International
Civil Aviation
Organization

Ref.: AN 4/1.1.57-17/44

Subject: Proposals for the amendment of Annex 14,
Volume I and PANS-Aerodromes (Doc 9981)

BACKGROUND INFORMATION

Rwy widths/shoulders (Code D and E)

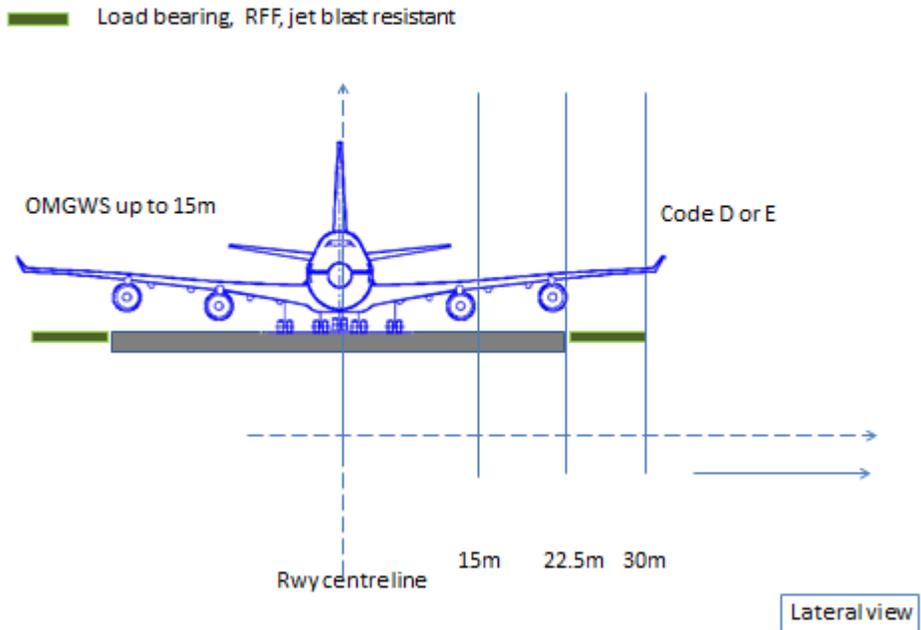
1. Runway widths and shoulders (Annex 14, Volume I, paragraph 3.1.10)

1.1 The following diagrams show the different runway and shoulders for OMGWS above 6m and up to 15m (covering nearly all commercial aeroplanes, Codes C, D, E and F)

3.1.10 **Recommendation.**— *The width of a runway should be not less than the appropriate dimension specified in the following tabulation:*

Code number	Outer Main Gear Wheel Span (OMGWS)			
	Up to but not including 4.5 m	4.5 m up to but not including 6 m	6 m up to but not including 9 m	9 m up to but not including 15 m
1 ^a	18 m	18 m	23 m	
2 ^a	23 m	23 m	30 m	
3	30 m	30 m	30 m	45 m
4			45 m	45 m

2. Taxiway widths and shoulders (Annex 14, Volume I, paragraphs 3.9.3, 3.9.4 and 3.10.1)

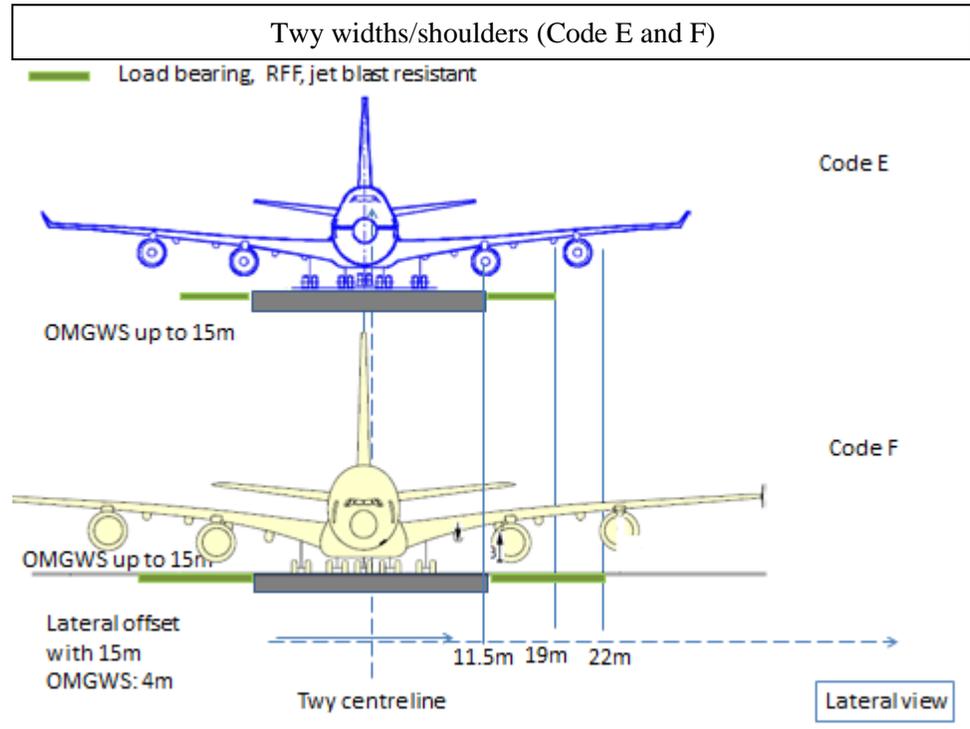
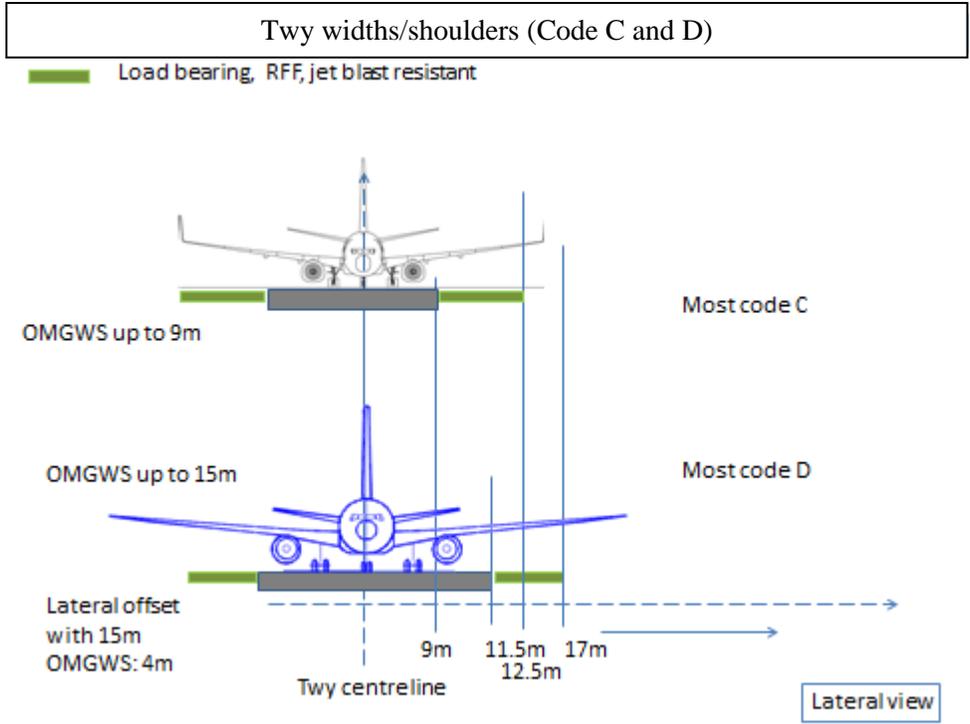
2.1 The following diagrams show the different taxiway and shoulders for OMGWS above 6m and up to 15m (covering nearly all commercial aeroplanes, Codes C, D, E and F).

OMGWS			
Clearance	Up to but not including 4.5 m	4.5 m up to but not including 6 m	6 m up to but not including 9 m	9 m up to but not including 15 m
	1.50 m	2.25 m	3 m ^a or 4 m ^b	4 m

OMGWS			
	Up to but not including 4.5 m	4.5 m up to but not including 6 m	6 m up to but not including 9 m	9 m up to but not including 15 m
Taxiway width	7.5 m	10.5 m	15 m	23 m

- ~~60 m~~ **44 m** where the code letter is F; and
- ~~44 m~~ **38 m** where the code letter is E; and
- ~~38 m~~ **34 m** where the code letter is D; and
- 25 m where the code letter is C.

3. Widths of runway strips for precision and non-precisions runways (paragraphs 3.4.3 and 3.4.4)

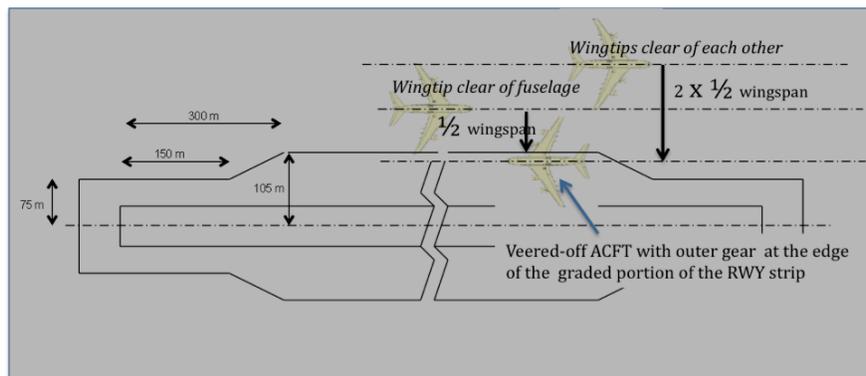
3.1 This is an extract of a paper (ADWG/7- DP/6) which discusses runway-taxiway separation and, by extension, explains the rationale for reduction of runway width.

3.2 For runways with precision approaches, the half-width of the graded portion of the strip is recommended to be between 75 and 105m, depending on the distance from the threshold. Using the higher value, this yields separations of (see figure below):

- a) For “protection” against wing-tip to fuselage contact (catastrophic):
 $\frac{1}{2}$ width of graded area + $\frac{1}{2}$ wingspan = $105 + 40 = 145\text{m}$
- b) For “protection” against wing-tip to wingtip contact (major):
 $\frac{1}{2}$ width of graded area – $\frac{1}{2}$ gear span + $\frac{1}{2}$ wingspan + $\frac{1}{2}$ wingspan = $105 - 7 + 40 + 40 = 178\text{m}$

(runway aircraft with its outer gear at the edge of the graded area)

- c) it shows that the worst case leads to a minimum runway-taxiway separation of 178m for code F, allowing for the extremely improbable deviation of an aircraft on the runway to the edge of the graded portion of the strip;
- d) this minimum runway-taxiway separation is rounded up from 178 to 180m;
- e) the 180 m includes the half wingspan of the aircraft on the taxiway (corresponding to 140m half strip + 40m half wingspan)
- f) thus, full protection is achieved with a half strip width of 140 m.

- ~~150 m~~ **140 m** where the code number is 3 or 4; and
- ~~75 m~~ **70 m** where the code number is 1 or 2;

- ~~150 m~~ **140 m** where the code number is 3 or 4; and
- ~~75 m~~ **70 m** where the code number is 1 or 2;

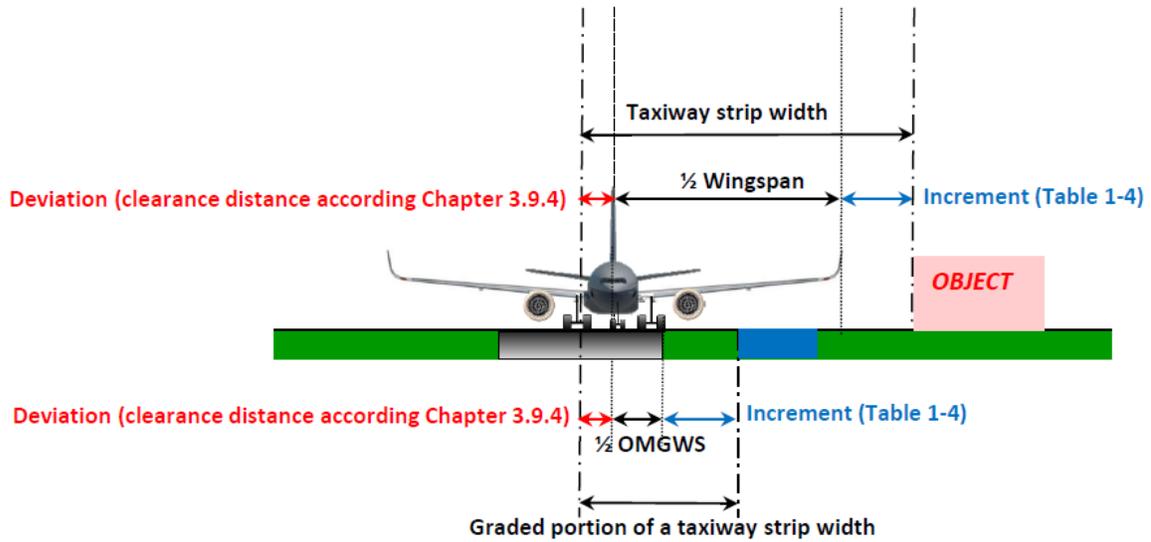
3.3 The same logic applies to lower codes on Instrument runways.
